AGENDA
Cascade Charter Township Planning Commission
Monday, August 15, 2016
7:00 pm
Cascade Library Wisner Center
2870 Jacksmith Ave. SE

STAFF REPORT: Case #16-3324
REPORT DATE: August 10, 2016
PREPARED FOR: Cascade Charter Township Planning Commission
MEETING DATE: August 15, 2016
PREPARED BY: Steve Peterson, Community Development Director

TO: Cascade Charter Township Planning Commission
FROM: Steve Peterson, Community Development Director
REPORT DATE: August 4, 2016
MEETING DATE: August 15, 2016
CASE: #16-3321/ Growney Mixed Use P.U.D amendment

STAFF REPORT: Case # 16-3318
REPORT DATE: August 5, 2016
PREPARED FOR: Cascade Charter Township Planning Commission
MEETING DATE: August 15, 2015
PREPARED BY: Steve Peterson, Community Development Director

SHEET TITLE:
TITLE SHEET/
SITE PLAN

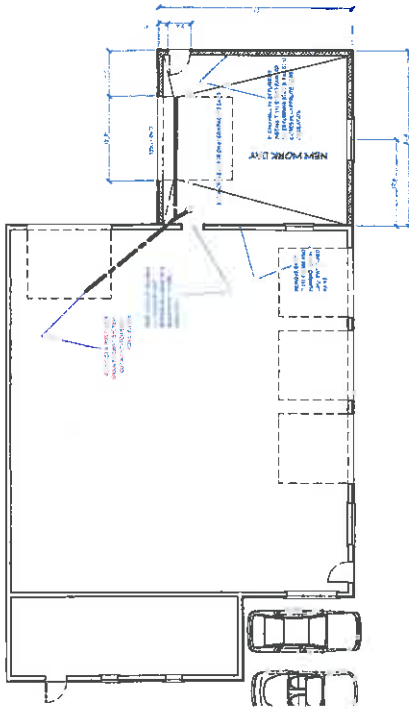
1. The applicant wants to construct a new addition on to the building to accommodate additional car storage. This project will also include the removal of the existing 573 sq ft shed to the north. Neither project will increase the amount of impervious space since the area is paved now.
2. Because the site is in the B1 zoning district and due to the fact that the addition is valued at over \$60,000 the design requirements of the B1 zone must also be met.
3. The owner has already asked and has received three variances to accommodate his addition

4. The township engineer has reviewed the plans and does not require any changes due to the fact that they are in storm zone C and they are not increasing the impervious area.

Approve the site plan addition. Obtain SESC from KCRC

PLAN REVISIONS		SITE PLAN		FIELD SURVEY / DATE:	
SITE PLAN SUBMISSION		FOR		RECORDS	
05-10-16		5505 52ND STREET ADDITION		DESIGNED BY: JFL	
				DESIGN DRAWN BY: FEF	
				CHECKED BY: JFL	
				PLAN DATE: 05-05-16	
				PROJECT NO.: 160161.01	
				SHEET NUMBER	
				2 OF 2

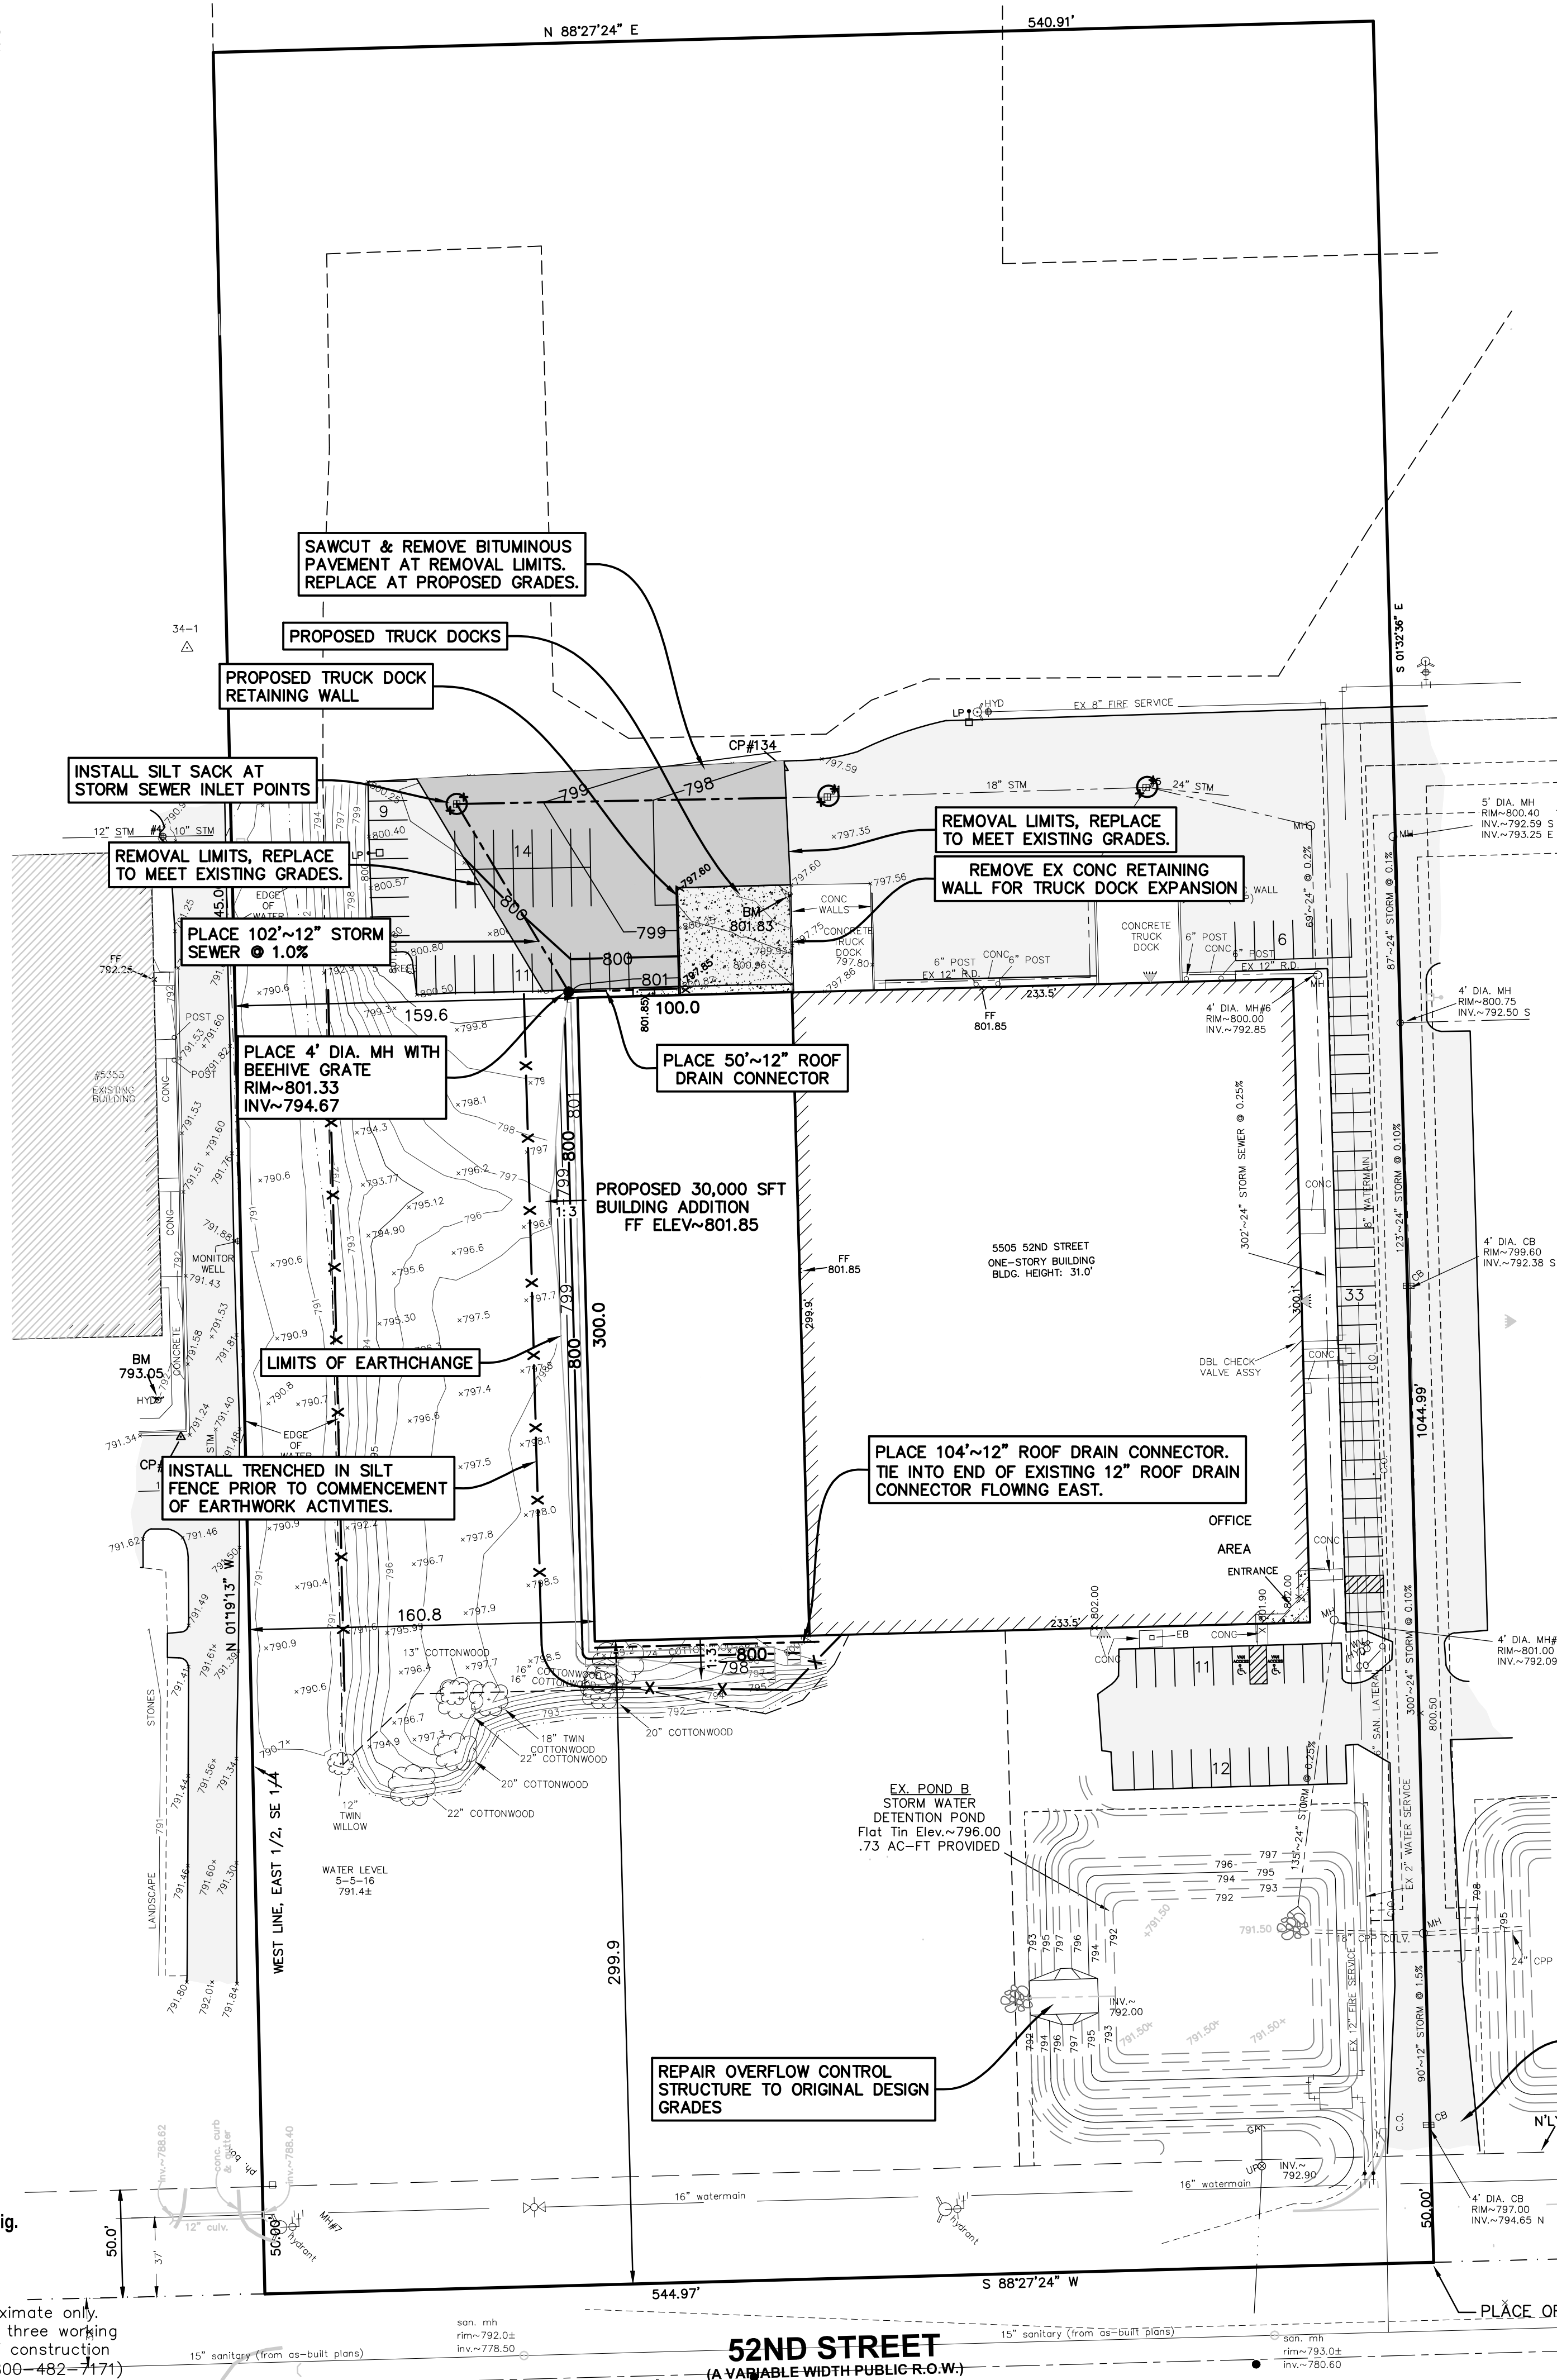
The applicant provided an as-built survey of the existing detention basins to verify the current storage capacity. At the time of the survey, there was approximately two feet of water in the ponds. It was discovered the pond outlet pipe was plugged and the obstruction was removed. It was also discovered the pond embankment was eroded and at a lower elevation than originally designed. The site plan was revised to repair the embankment to the original design elevations.

The MDEQ conservation easement along the west side of the property is 40 feet wide, extends the length of the property, and is located adjacent to the property line. This area of the easement has caused nuisance ponding of water on the adjacent property to the west. The applicant's site plan indicates at the time of the topographic survey, the water level in the easement is only a few inches below the parking lot to the west.

The original site plan for the development, dated 2004, established the existing MDEQ conservation easement. The 2004 site plan provided proposed contours for the easement along the west side of the property that indicated a positive channel slope from north to south. However, the current site plan and topographic survey show this area to be very flat, no slope from north to south. It is unclear if this area was not constructed to plan originally, if accumulated sediment and vegetation filled it in over time, or other factors influenced the drainage patterns.

The applicant has submitted drawings, calculations, and additional documentation as required in the SWO Section 2.03, Drainage Plan. Please refer to the included checklist for items and comments on each item. Please note a maintenance agreement is required before construction begins. The agreement should be submitted to the Township for review.

- NR (11) Maintenance agreement, in form and substance acceptable to the Township, for ensuring maintenance of any privately owned storm water runoff facilities. The maintenance agreement shall include the developer's written commitment to provide routine, emergency, and long-term maintenance of the facilities and, in the event that the facilities are not maintained in accordance with the approved drainage plan, the agreement shall authorize the Township to maintain any on-site storm water runoff facility as reasonably necessary, at the developer's expense
Maintenance agreement was not provided and is required.
